ABS T3 Feedback

Model Name: BFX-AT100

Document Version: ALT_STB_MP_CSMTINS_001

Issued Date: 2023.01.17

ABS Top case - Top view

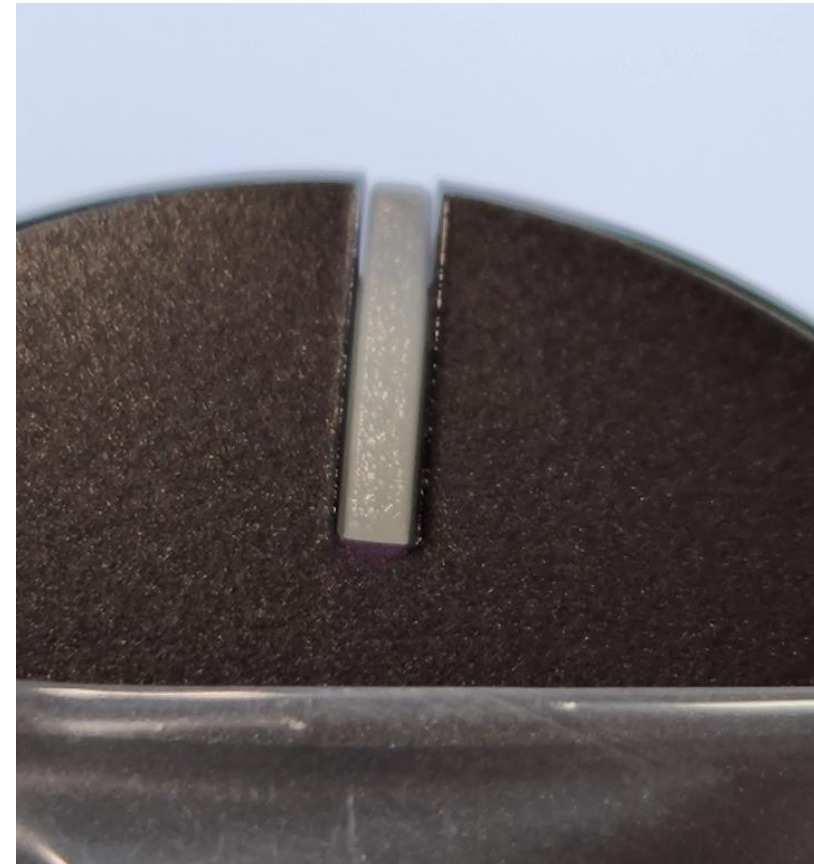
- Large gap between LED leans and Top case
 - Fix the gaps same as PC top case
 - PC top case was very small gap between LED leans and Top case
